**Pacific Gas and  
Electric Company**

PG&E Letter DCL-03-121

Docket No. 50-323, OL-DPR-82  
Diablo Canyon Unit 2  
PG&E Response to NRC Questions on 2R11 Steam Generator Tube Inspections

**PG&E Response to NRC Questions on Unit 2 Eleventh Refueling Outage  
Steam Generator Tube Inspection 90-Day Report**

Figure 2-1

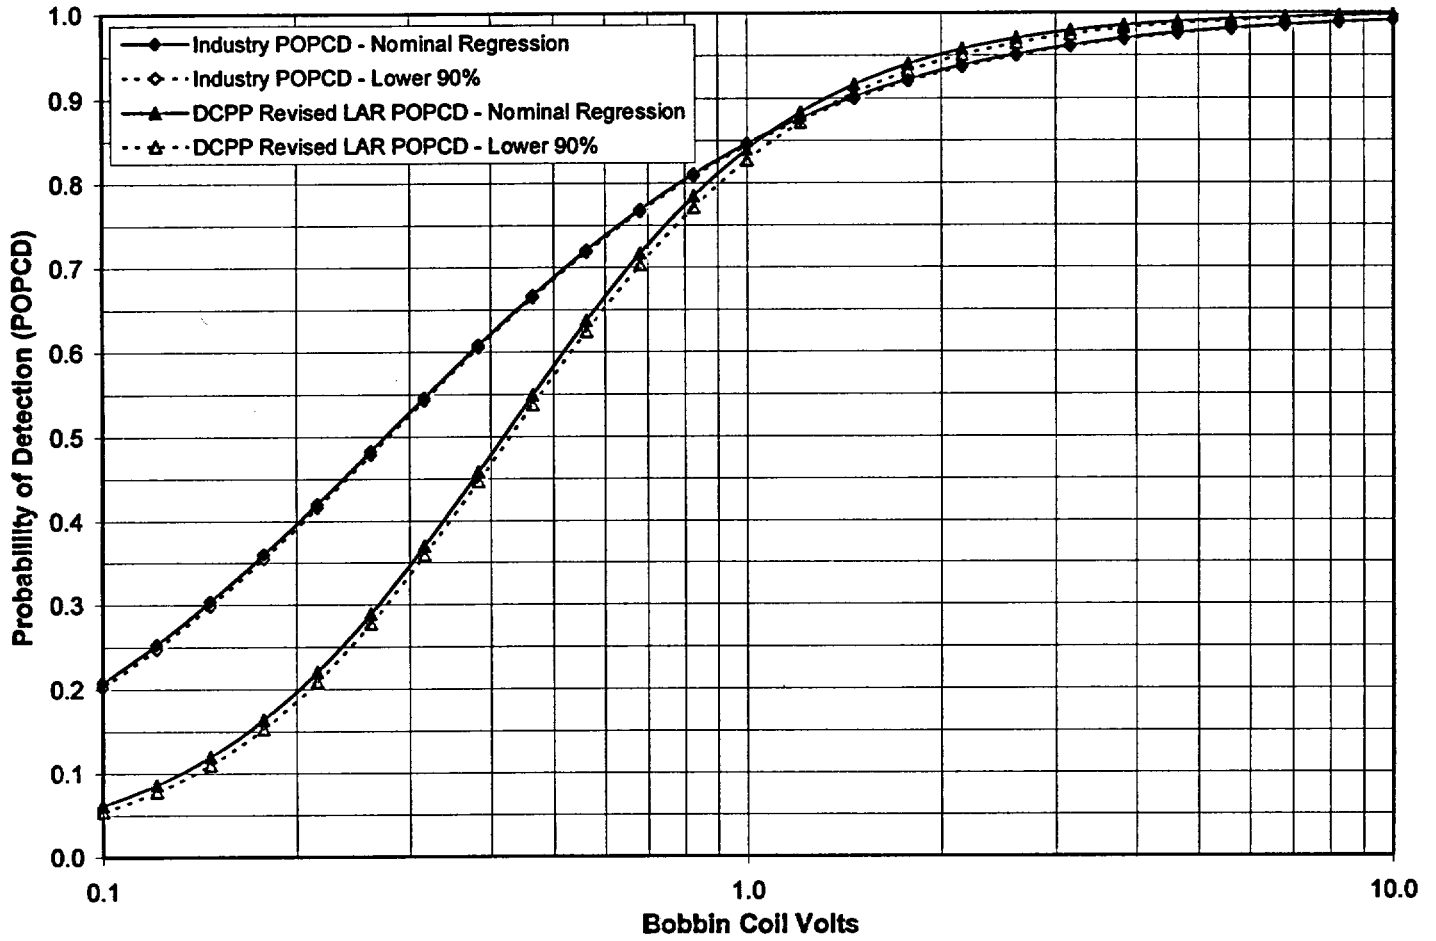
NRC Question No. 2:

*"With respect to the POPCD evaluation, the POPCD function at each outage should only include data that was available at that time. A generic POPCD which includes data from other plants (at that time) may be used consistent with the methodology for determining when a generic POPCD curve should be used (versus a plant-specific POPCD)."*

PG&E Response:

PG&E has reviewed these preliminary guidelines with respect to benchmarking applications in response to the NRC request. After the 2R11 inspections for DCPD Units 1 and 2 the three minimum data requirement criteria are satisfied, and, therefore, have an adequate database to define a plant-specific POPCD for Unit 2 Cycle 12. However, for prior cycle benchmarking, DCPD Units 1 and 2 do not satisfy all three minimum data requirement criteria, mainly due to not satisfying the third criteria regarding a minimum of 20 detected and RPC confirmed indications above 2.0 V. As shown in Figure 2-1, which compares the industry POPCD with the DCPD-specific POPCD (revised POPCD from Figure 1 of PG&E Letter DCL-03-109, "Supplemental Information to Support License Amendment Request 03-10, 'Revised Steam Generator Voltage-Based Repair Criteria Probability of Detection Method for Diablo Canyon Unit 2 Cycle 12,'" dated September 3, 2003), the DCPD-specific POPCD yields a POD less than 0.35 at 0.1 V, but yields a uniformly higher POD above 1.0 V. As a result, the industry POPCD must be used for prior cycle benchmarking. Below, Table 2-1 provides the industry POPCD correlations utilized in the benchmarking calculations. The industry POPCD curve is from Table 1 of PG&E Letter No. DCL-03-078, "License Amendment Request 03-10, 'Revised Steam Generator Voltage-Based Repair Criteria Probability of Detection Method for Diablo Canyon Unit 2 Cycle 12,'" dated June 26, 2003.

Figure 3-1

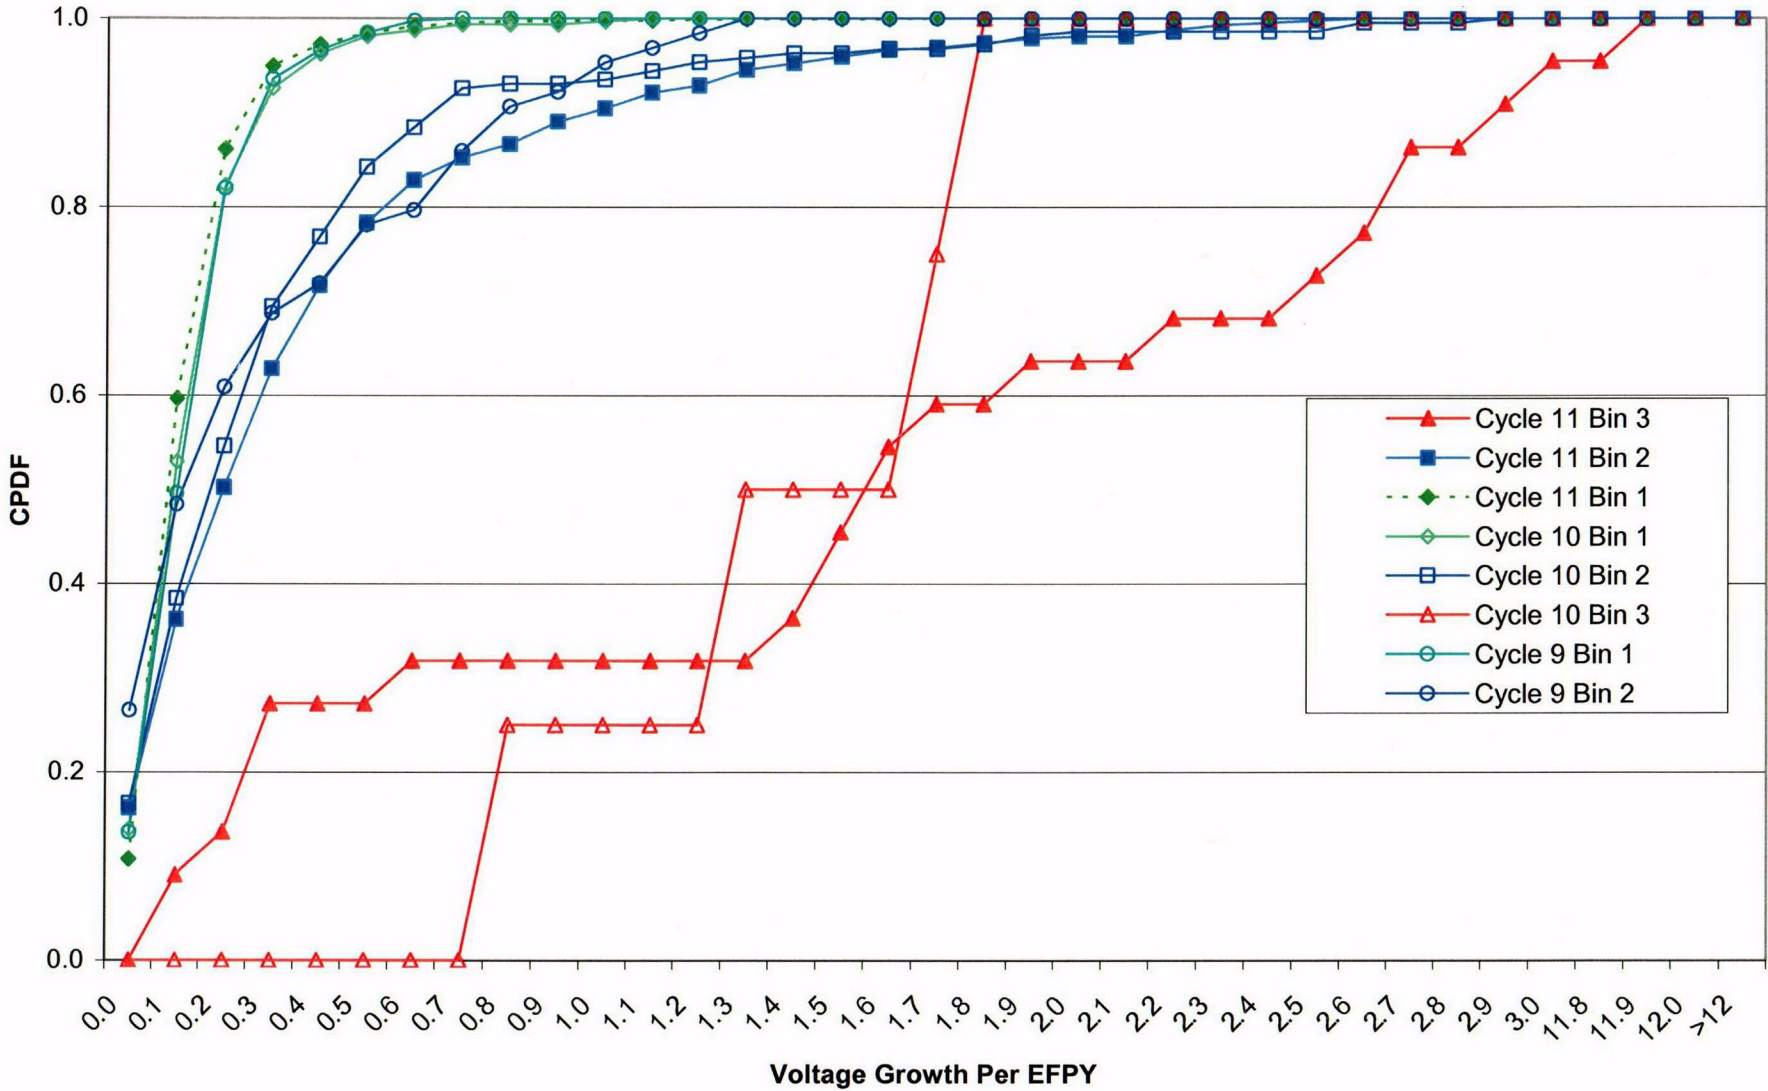
NRC Question No. 3:

*"With respect to the voltage dependent growth distribution, the staff notes that for the cycle 12 operational assessment, the middle voltage growth bin was increased by 10% during this assessment. Similar adjustments to the data for each cycle should be considered in this assessment if the data supports such an increase. In addition, the method by which this value is determined should be discussed. This adjustment was based, in part, on a comparison of Figures 3-22 and Figures 3-28. Please combine these two figures on one graph since the staff could not readily discern the 10% increase in this bin versus increases in other bins. Additional justification for increasing the middle bin by 10% was based on the data plotted in Figure 3-29. Please provide a similar assessment with the voltage growth data divided into voltage bins since Figure 3-29 shows an increase of 10% in growth for all indications (i.e., address whether the increase in growth in the middle bin is consistent with the overall increase in voltage growth)."*

PG&E Response:

As requested, Figure 3-1 below combines Figures 3-22 and 3-28, and provides the Cycles 10 and 11 voltage dependent growth (VDG) data divided into the Cycle 11 Bins (0-0.59, 0.59-1.66, >1.66 volts per effective full power years (V/EFPY)) on a single graph. Also included is the Cycle 9 data for Bins 1 and 2 for comparison as well (No Bin 3 data was present in Cycle 9). Table 3-1 depicts the average Bin 2 growth rates for each SG for Cycles 9, 10, and 11, as well as the average of all four SGs, using the Cycle 11 VDG breakpoints. The increase in average growth rate for all SGs in Bin 2 was 19 percent from Cycles 9 to 10 and 21 percent from Cycles 10 to 11. From Figure 3-1, it is seen that the cumulative distributions for Bin 2 (and Bin 1) remain relatively constant with minor oscillations in either direction over the last three cycles, but do not indicate a consistently increasing growth rate. Below about 0.9 cumulative probability distribution function (CPDF), Cycle 9 Bin 2 growth is comparable to Cycle 11 and larger than Cycle 10. Only 64 data points were present in Cycle 9, compared to 216 data points in Cycle 10 and 420 in Cycle 11. The Cycle 11 data is, therefore, considered a more mature population than Cycle 10, and as such is more representative of the VDG that is occurring to Bin 2 indications. As the population continues to mature, the Bin 2 growth curve will continue to shift towards the left on the CPDF curve (as additional slower growing data points are added) and then maintain relative consistency from cycle to cycle. The VDG data from European SGs that was presented to the NRC staff during the March 4, 2003 meeting supports the mature growth phenomenon of a large population of indications. Even though the Bin 2 data from Cycle 11 suggests a similarly mature population and the Bin 2 growth rate is not expected to significantly increase or decrease over Cycle 12, the Cycle 12 OA used a 10 percent increase to the Cycle 11 Bin 2 growth data.

Figure 4-1

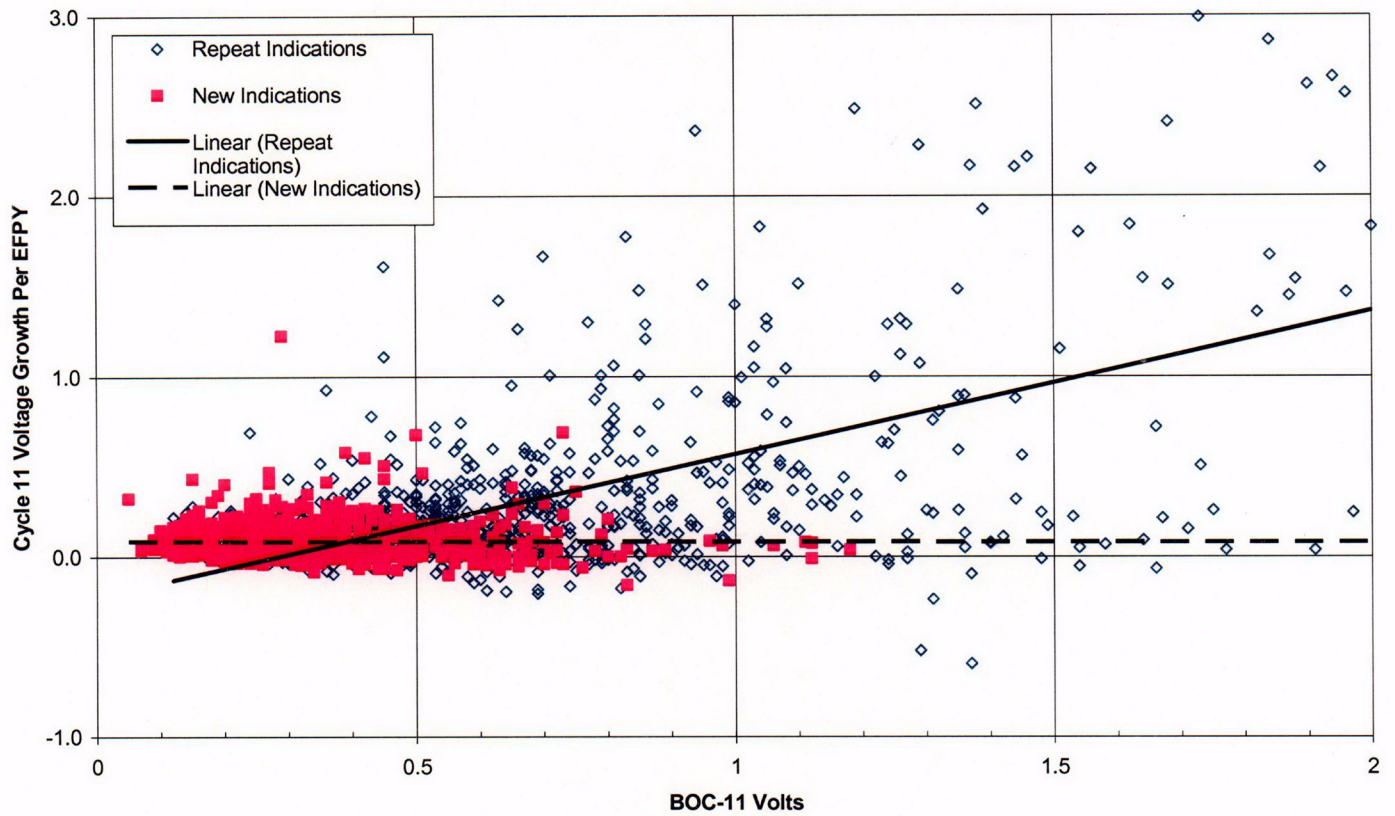
NRC Question No. 4:

*"The staff notes that the process of re-evaluating the data from the previous outage in determining the growth rate distribution result in the inclusion of many low growth rate indications. This reevaluation is an accepted practice; however, it may result in forcing voltage calls for eddy current signals which may not really represent the presence of a flaw resulting in a non-conservative growth rate distribution (since the frequency of the larger voltage growth rates is reduced). As a result, the growth rates for these indications may actually be higher (i.e., since the indications may have initiated during the course of the cycle rather than truly being present for the whole cycle). Your benchmark assessment should consider the effect of removing these indications from the growth rate distribution to determine if this re-evaluation process is resulting in non-conservative projections. An assessment of whether exclusion of this data affects the breakpoints in the VDG rate distribution should also be considered. The staff notes that you have observed that new indications are not exhibiting as much voltage dependent growth as repeat indications. Your assessment should address whether this could be a result of the above effect."*

The Cycle 11 growth data for all SGs (previously provided in Figures 3-10 to 3-13 of the 2R11 90-day report) is consolidated on a single graph in Figure 4-1 below, trending new and repeat indication voltage dependent growth rates. The figure clearly depicts that voltage dependent growth is primarily occurring in repeat indications. This is the expected condition due to the exponential dependence of volts on depth. The low voltages of the new indications suggest that they are shallow so the exponential effect on growth is minimal for them, compared to the higher voltage repeat indications that are likely deeper. In Figure 4-2 below, new and repeat cumulative growth curves were plotted along with the Cycle 11 voltage independent growth curve. This figure shows that the repeat indications do in fact grow faster than new indications. The graph also shows the independent curve does not bound the repeat growth, and as such, if the

**Figure 5-1: Comparison of tri-linear fit of the growth data  
to a 3<sup>rd</sup> order polynomial fit**

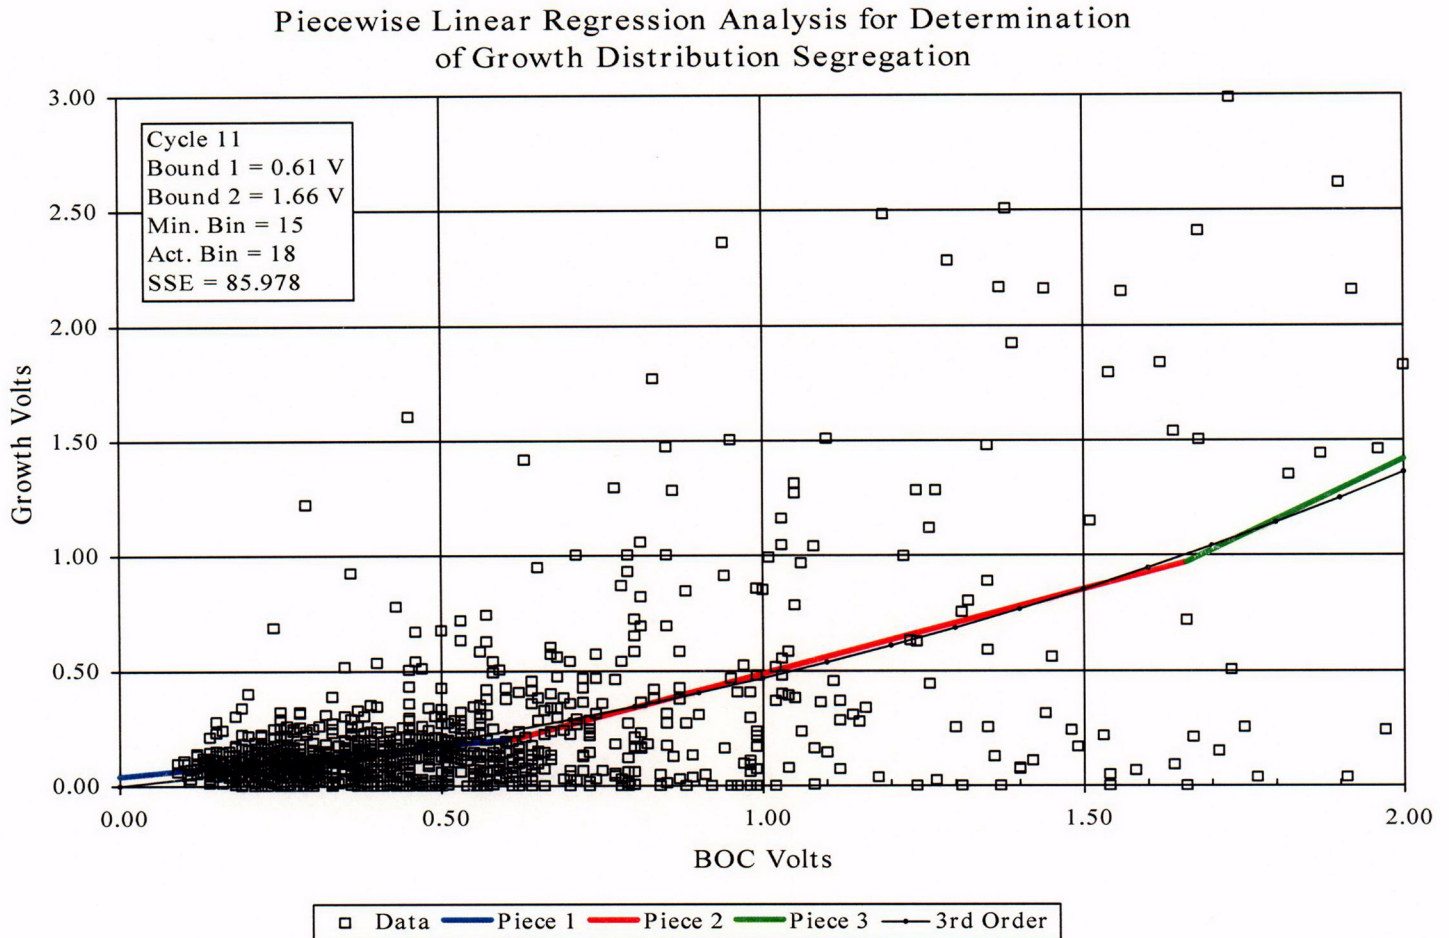
NRC Question No. 5:

*"With respect to the breakpoints in the VDG rate curves, discuss any physical insights of why the growth rates would change as a function of initial voltage amplitude (or more specifically what is occurring below 0.59 volts that is different from what is occurring between 0.59 and 1.66 volts). Discuss whether you have any insights of whether these breakpoints would change with time or would be well defined if a larger dataset were evaluated."*

Bobbin coil voltage increases exponentially with depth and again exponentially with throughwall crack length. Consequently, for a given incremental growth in depth, the associated incremental increase in voltage will tend to increase exponentially with BOC depth and associated BOC volts. For low voltages, the exponential effect can be approximated as a linear effect and voltage growth is not a significant function of BOC volts. This concept is recognized in GL 95-05, which notes that an assessment is recommended to determine the voltage above which voltage growth becomes a significant function of BOC volts. Below about 0.59 V, ARC historical data have shown negligible VDG as also seen in the DCPD 2R11 data of Figure 5-1. Between about 0.59 V and 1.66 V, the DCPD growth data show a growth trend increasing with BOC volts, which reflects the deeper indications at the higher voltages. It can be reasonably expected that the VDG breakpoints will change moderately with time as the number of higher voltage indications increases. As more slow growing indications progress to higher voltages (population matures), it may be expected that the frequency of large growth rates in the VDG bins will decrease. This behavior is seen in European voltage growth data based on large populations of high voltage indications. The European data show incremental increases in growth with increases in BOC voltage, which tends to indicate that the VDG breakpoints become well defined with large datasets.

A piecewise linear fit to the data provides an advantage to a straight linear fit in that it provides an approximation to a polynomial or exponential relation. This can be seen by examining the comparison provided on Figure 5-1. In Figure 5-1 the distribution of growth as a function of initial voltage was fit to a third order polynomial in order to include the zero growth values in the regression. The dependence is not strong nonlinear. The index of determination,  $R^2$ , for a 1<sup>st</sup> order fit to the data is almost 31 percent while the value for a 3<sup>rd</sup> order polynomial is a little more than 32 percent. This indicates that the use of a polynomial does not result in a large increase in explaining the variance of the prediction by adding two orders of complexity to the model. However, it is apparent that accounting for the potential increase in the dependency by performing a trilinear fit is worthwhile in that predicted future indications will have larger amplitudes in greater proportion.

Figure 10-1

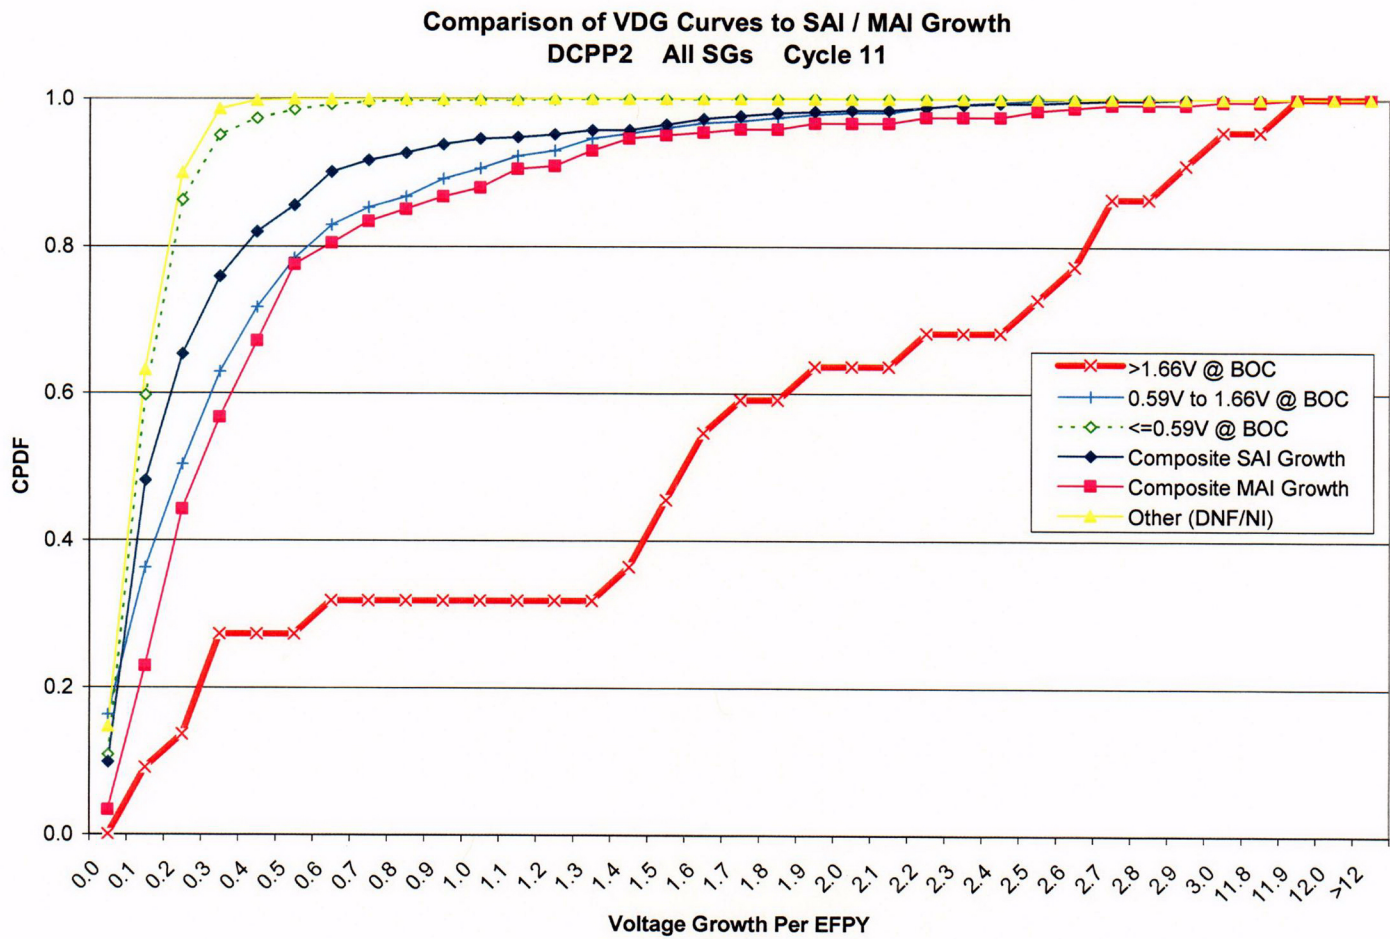
NRC Question No. 10:

*"Table 3-4 of Enclosure 4 to your June 23, 2003 letter, lists the largest voltage growth rates observed during cycle 11. All of these indications were single axial indications. Please discuss whether the growth rate distribution for single axial indications is different than that for multiple axial indications and whether separate growth rate distributions should be used for assessing these data sets. If so, please discuss whether additional rotating probe testing would need to be performed to determine which indications are single axial indications and which ones are multiple axial indications (or volumetric)."*

The Cycle 11 growth rate data was segregated into categories for single and multiple confirmed axial indications. A total of 750 DOS were confirmed during the Plus Point inspections performed at 2R11 (240 multiple axial indications (MAIs) and 510 SAI). The remaining 1103 DOS were either not Plus Point inspected (NI) or did not confirm (DNF) by Plus Point as degradation. The voltage growth for these indications is depicted graphically in Figure 10-1 below. As expected, the voltage growth for the TSP intersections affected by MAIs is higher than that for intersections that are affected by SAIs. The reason for this

affect is that the bobbin coil voltage is an "integral" of all the flaws present at the TSP, so a change in depth of any of the secondary flaws present or the development of an additional flaw during a cycle would have a higher resultant growth rate compared to a primary SAI growing only in depth during the cycle. The DNF/NI curve in Figure 10-1 contains the indications that were not Plus Point inspected or did not confirm with Plus Point. It is important to note that if more of these indications had been inspected with Plus Point, the result would have been to "pull" the SAI and MAI growth curves further to the left, since a large number (about 90 percent of 1103) of lower growth values would be added to those curves based on the overall DOS confirmation of about 90 percent. Therefore, additional Plus Point inspections are not warranted in an effort to determine which indications are SAIs and which ones are MAIs. Since the growth data show the expected trend that MAI growth is moderately larger than SAI growth and that the non-Plus Point inspected population could further reduce the differences, it is further concluded that there is no need to separate MAIs and SAIs in the growth distributions used for OA analyses.
